**Device** TC1798/93/91, TC1748  
**Marking/Step** ES-AB, AB  
**Package** see Data Sheet

## 02698AERRA

This Errata Sheet describes the deviations from the current user documentation.

**Figure 1 Timing concerning equidistant multiple timers**

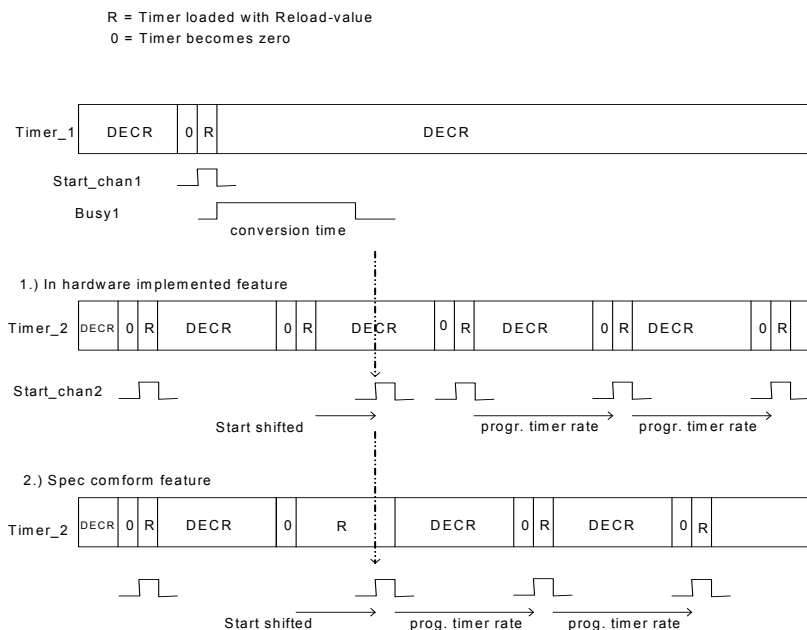
Timer\_1 becomes zero and starts a conversion. Timer\_2 becomes zero during this conversion is running and sets the conversion-request-bit of channel\_2. At the end of the conversion for channel\_1 this request initiates a start for channel\_2. But the Timer\_2 is reloaded only when setting the request-bit for channel\_2 and is decremented during the conversion of channel\_1.

The correct behavior would be a reload when the requested conversion (of channel\_2) is started.

Therefore the start of conversion for channel\_2 is delayed by maximum one conversion-time. After this delay it will be continued with equidistant conversion-starts. Please refer to the following figure.

Use one timer base in combination with neighboring trigger and selection by software which result has to be taken into account.
